ITR SET NOTE:
 THESE ITR SET DRAWINGS HAVE BEEN MARKED UP WITH KNOWN MARKUPS/REVISIONS IN PROCESS AS NOT TO BE RE-COMMENTED ON VIA THE ITR PROCESS & ADVISE ITR REVIEWER OF KNOWN FORTCOMING CHANGES. THESE MARKUPS HAVE BEEN DONE / IDENTIFIED WITH YELLOW BACKGROUND TEXT BOXES. PLEASE USE ALTERNATE COLOR FOR ITR COMMENTS WHICH I WILL REVIEW / TAKE INTO CONSIDERATION BEFORE CADD/DESIGN IS TO EXECUTE.

| DEPARTMENT OF THE NAVY NAVAL FACILITIES ENGINEERING COMMAND ~ MID-ATLANTIC JACKSONVILLE, NC MCB CAMP LEJEUNE JACKSONVILLE, NC P1338 II MEF SIMULATION/TRAINING CENTER REPLACEMENT MECHANICAL - SITE PLAN | | |

PRE-FINAL ITR SET 2021-05-28

HVAC - 1ST FLOOR PLAN - OVERALL
SCALE: 1/16" = 1'-0"

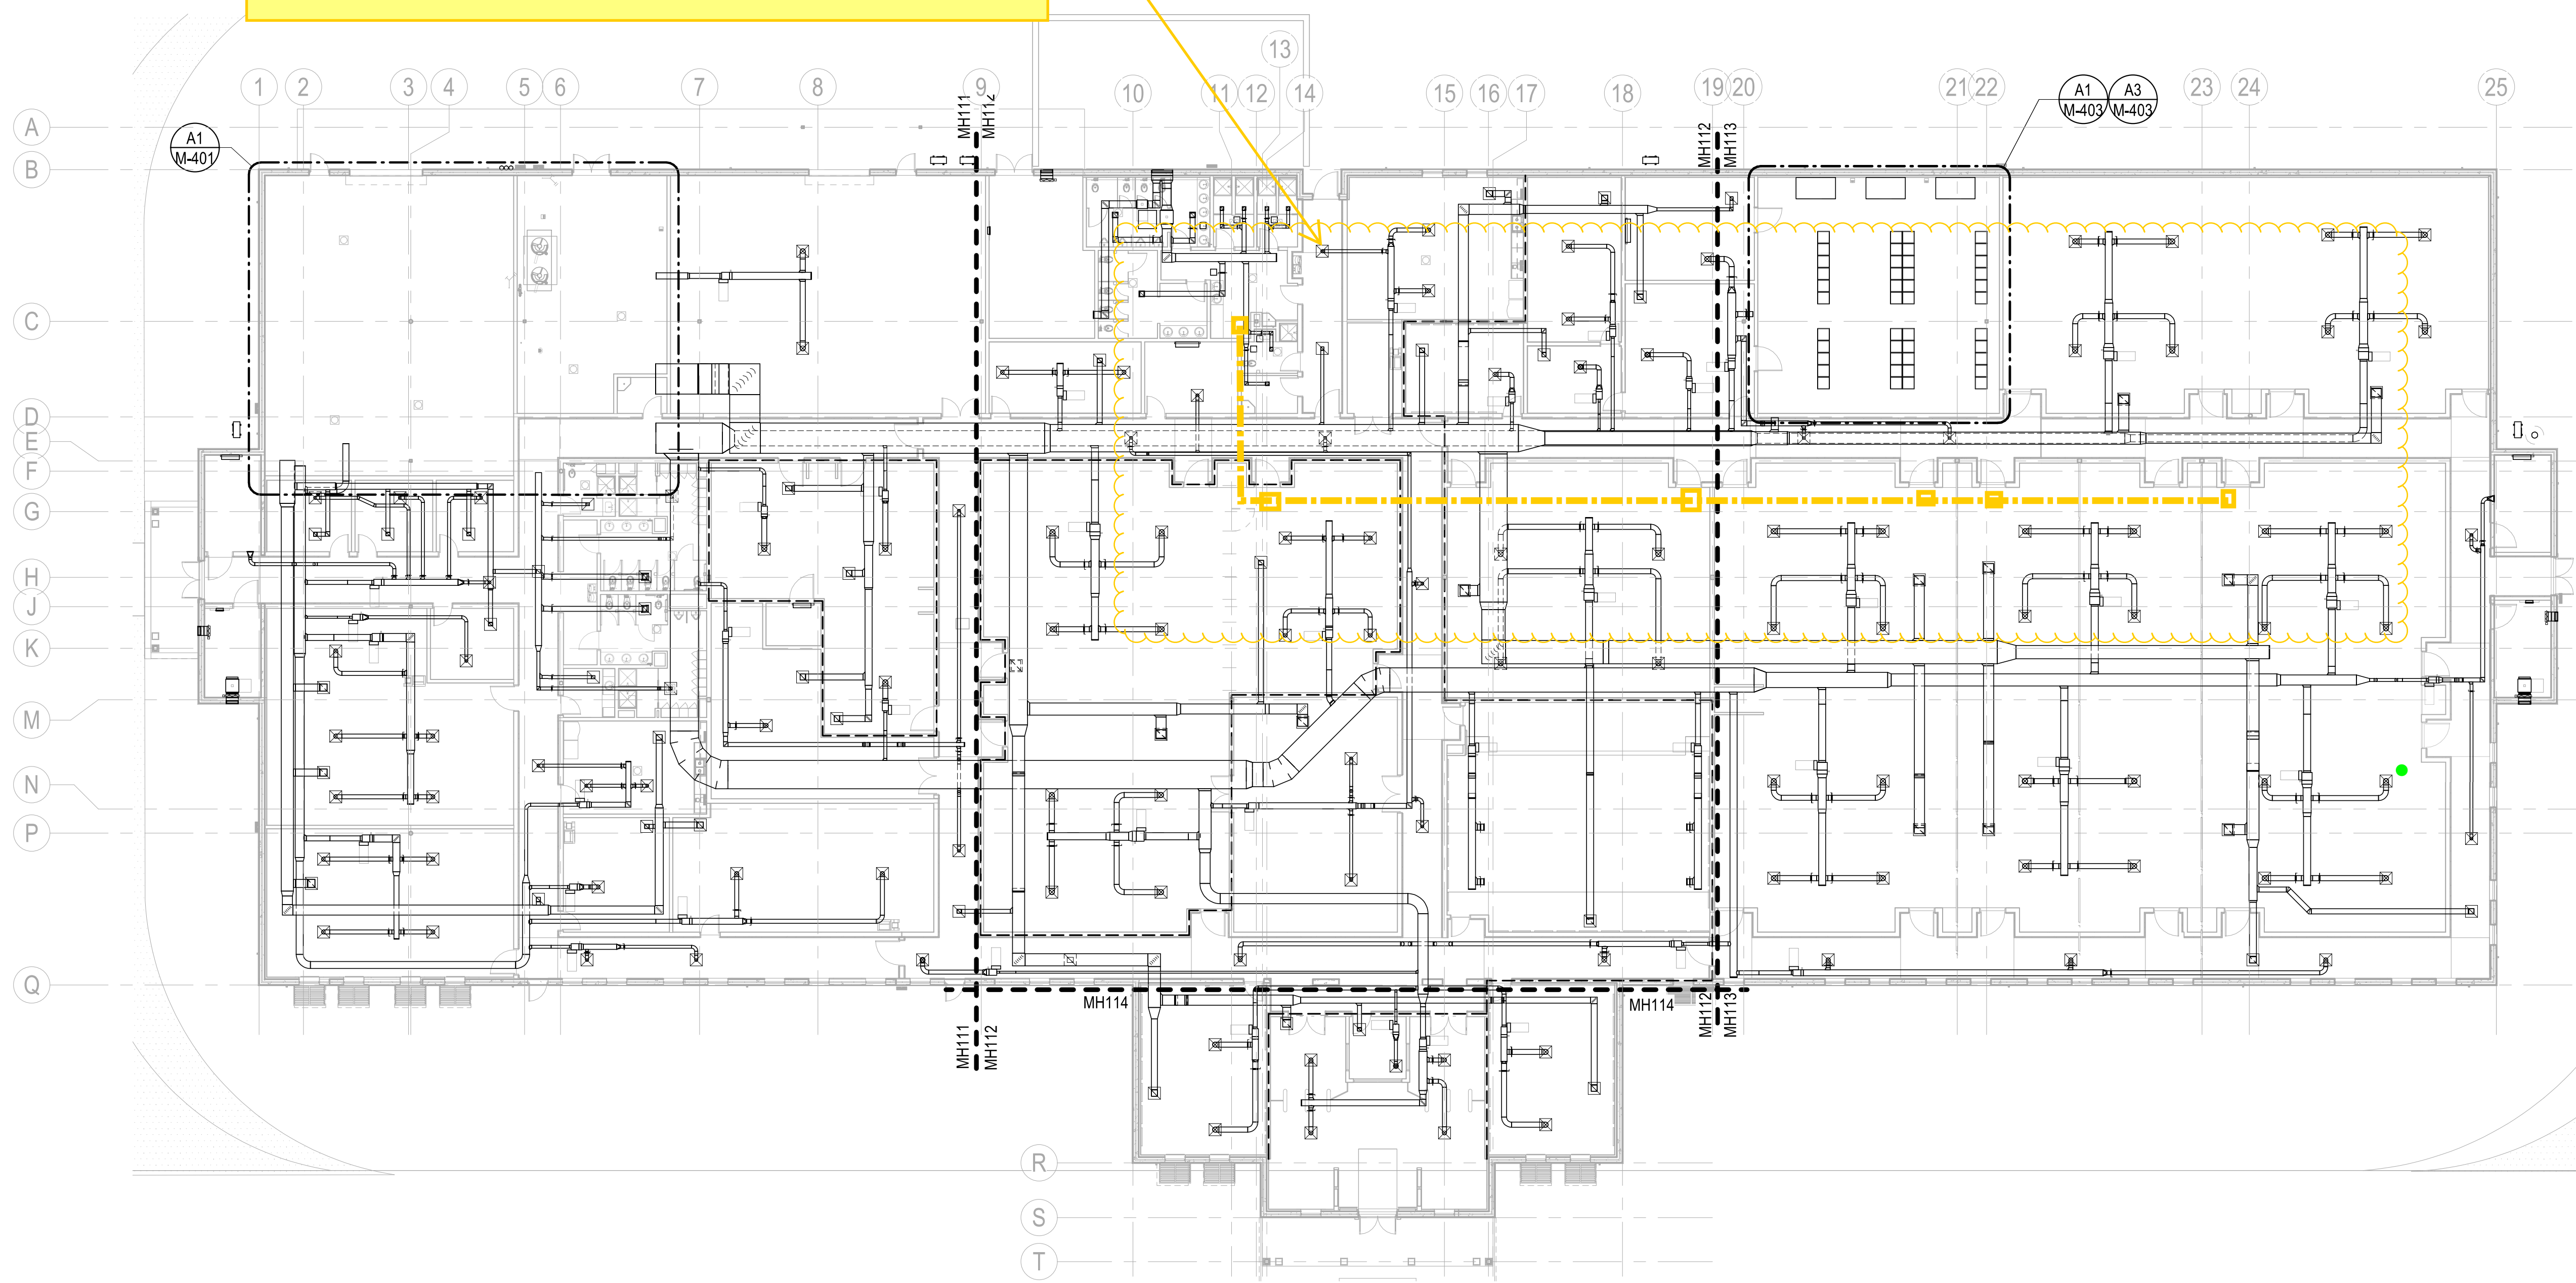
PROVIDE TRANSFER AIR DUCT SYSTEM CONNECTED TO TRAINING SPACES TO TRANSFER/PULL THE 1650 CFM EXHAUST REQUIRED IN SECURE AREA TOILETS; SIZE DUCT @ 0.05" = 24x12 or 18x18 (whatever can be routed easiest). ALL DEVICES CONNECTED SHALL BE TAG "D" AS CURRENTLY SCHEDULED

INDICATE DUCT RUN-OUT SIZES TO "D" GRILLES ON THE PLANS

HVAC - 1ST FLOOR PLAN - AREA A
 SCALE: 1/8" = 1'-0"

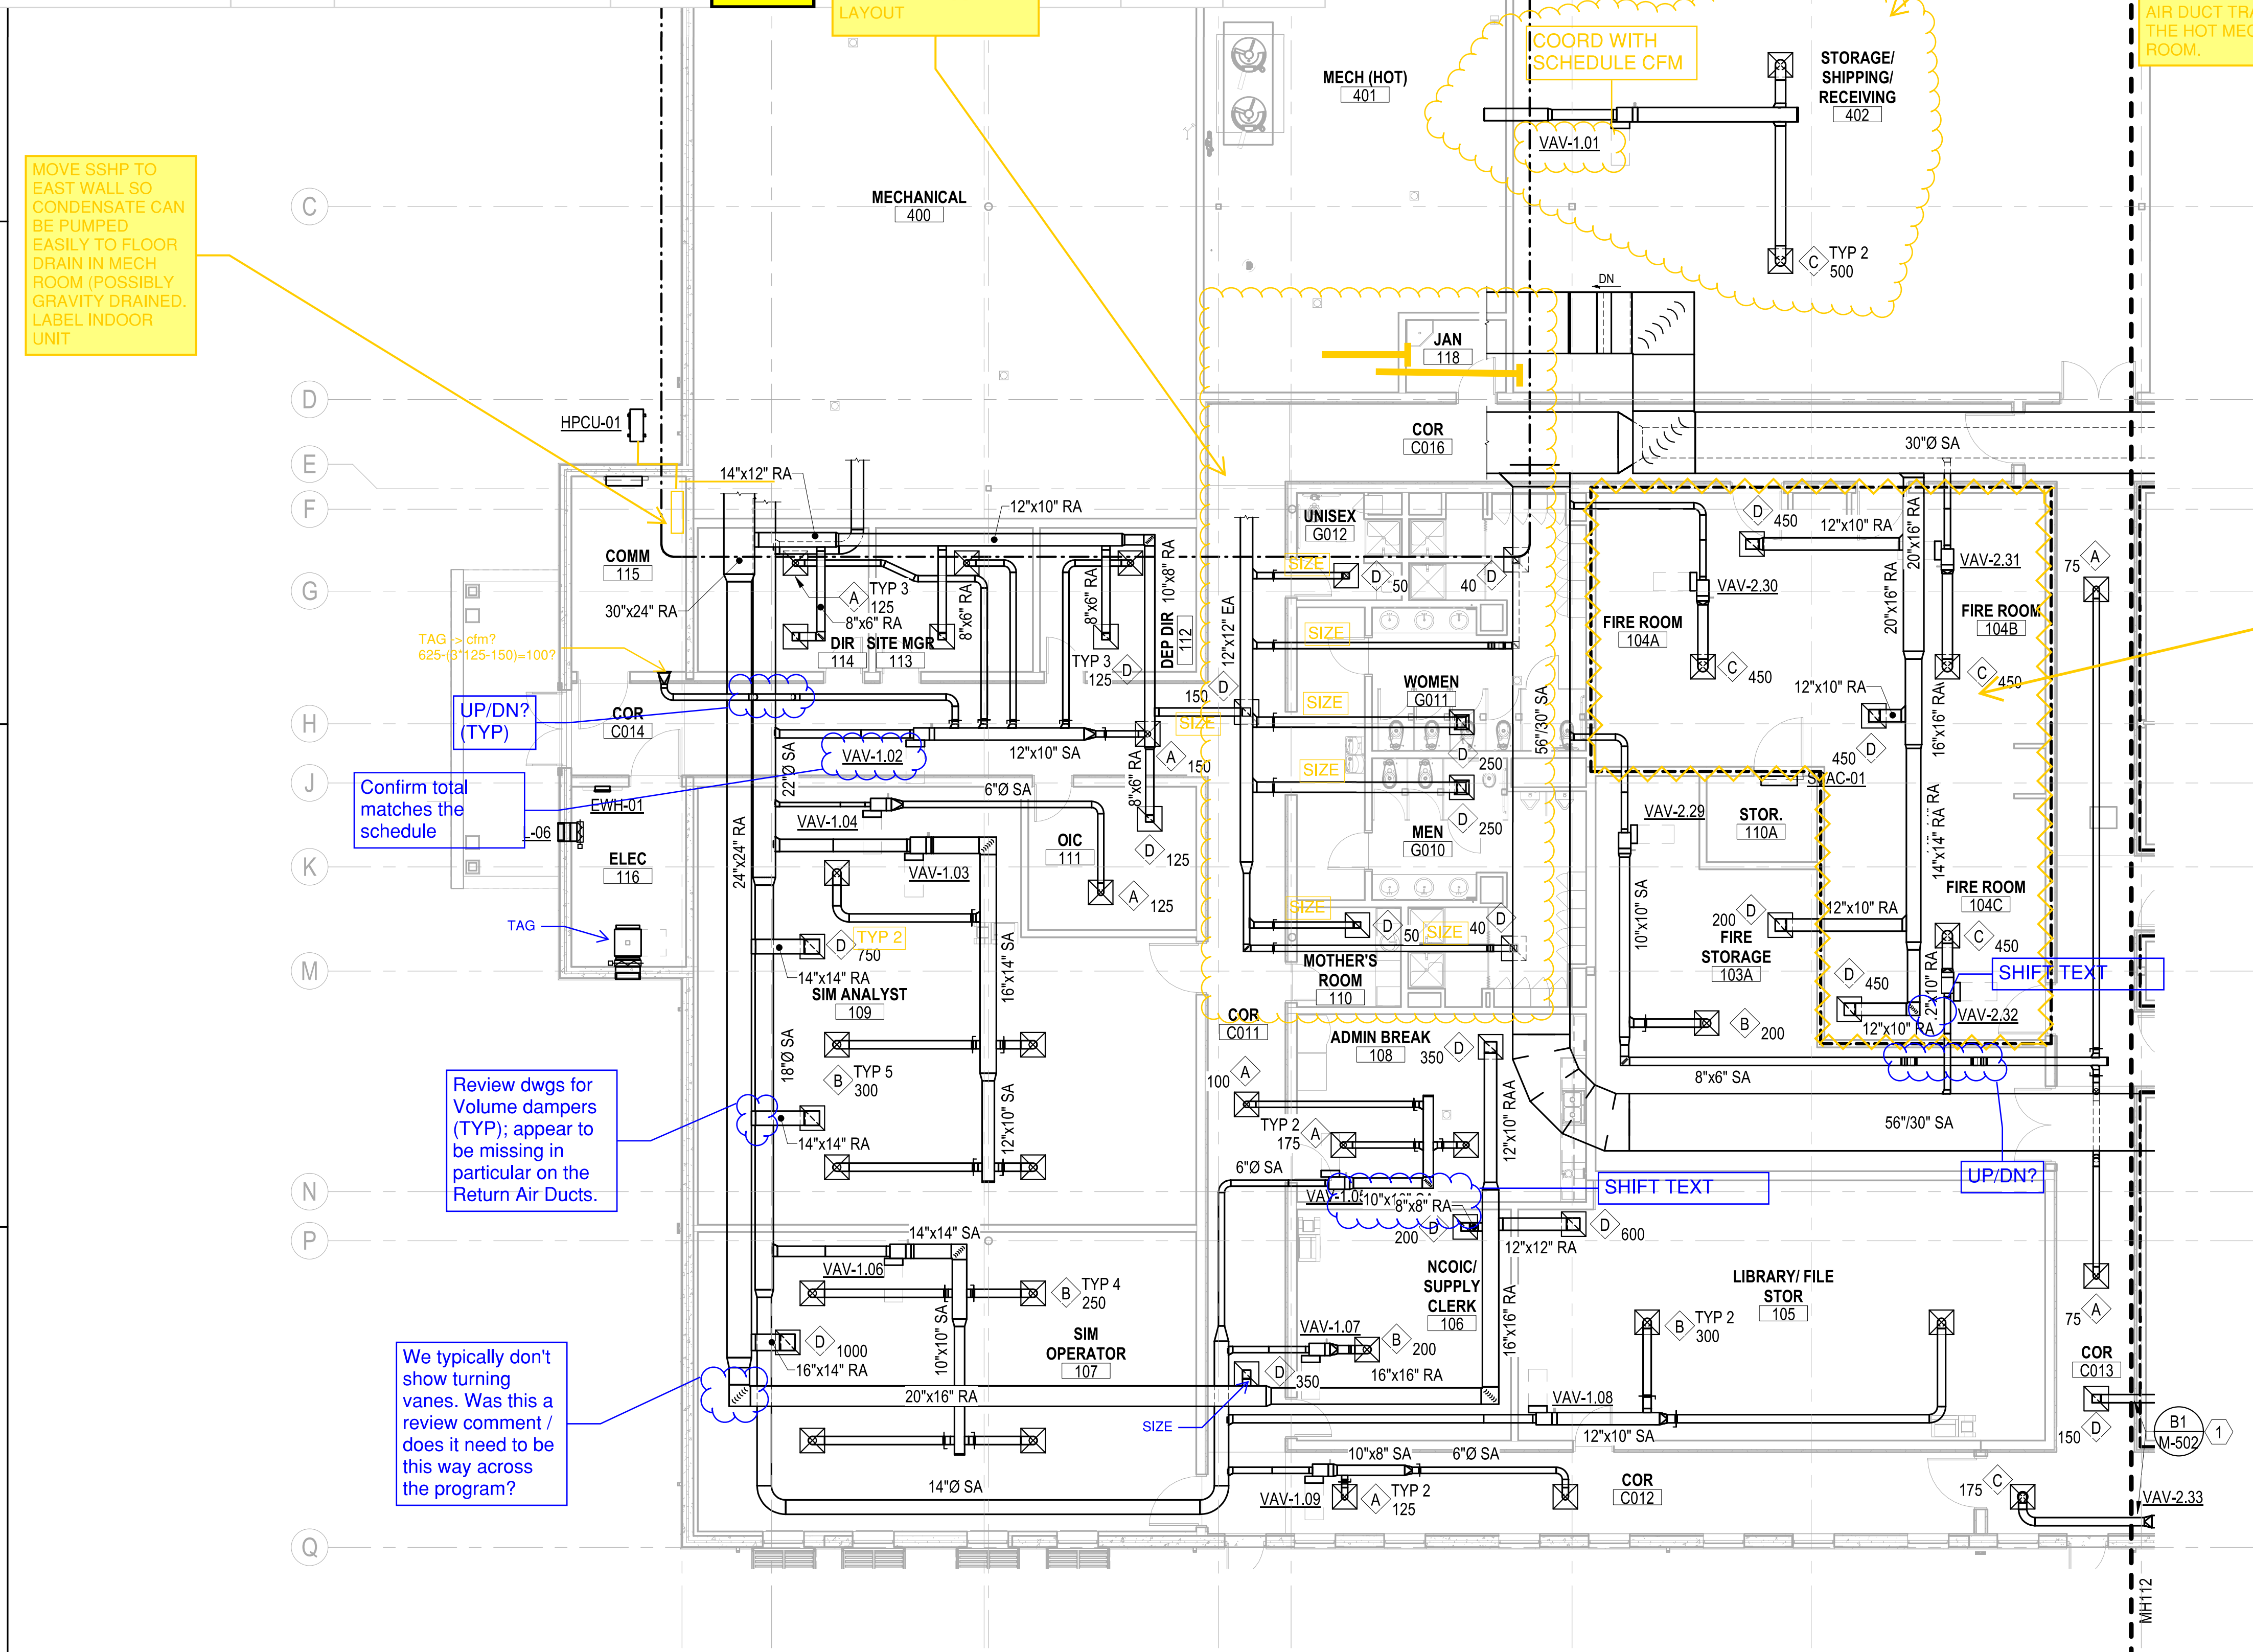
One 100 cfm between Shwr & Toilet
 Two 125 cfm over toilets, One 100 cfm in locker area
 Two 75 cfm Exhaust registers - 1 per shower
 Two 125 cfm over toilets, One 100 cfm in locker area
 Two 75 cfm Exhaust registers - 1 per shower
 Provide Single Exhaust Register @ 100 cfm
 Provide Single Exhaust Register @ 50 cfm

REVISE EXHAUST LAYOUT

TAG > cfm?
 625-(3*125-150)=100?

UP/DN? (TYP)

Confirm total matches the schedule

Review dwgs for Volume dampers (TYP); appear to be missing in particular on the Return Air Ducts.

We typically don't show turning vanes. Was this a review comment / does it need to be this way across the program?

IS THERE CEILING IN HERE? IF NOT PROVIDE DRUM LOUVERS OFF ROUND DUCT HIGH IN SPACE; NEED VAV BELOW 12'. DON'T LIKE THIS ONE COLD AIR DUCT THAT PASSES OVER "HOT MECH" - SO CANNOT LOCATE BOX OVER HOT MECH, ONLY DUCTWORK (ADD NOTE WHERE DUCT CROSSES HOT MECH TO PROVIDE OUTDOOR RATED VAPOR BARRIER ON INSULATION OF COLD AIR DUCT TRAVERSING THE HOT MECHANICAL ROOM.

REVISE DUCT LAYOUT - ONE BRANCH IN FOR VAV'S 2.30, 2.31, 2.32, ONE RETURN OUT - THE FIRE ROOM WALL PERIMETER IS "SECURE WALL" - CALL OUT TO DETAIL REQ'D. DON'T CROSS WALL WITH SUPPLY OR RETURN ASSOCIATED WITH VAV 2.29
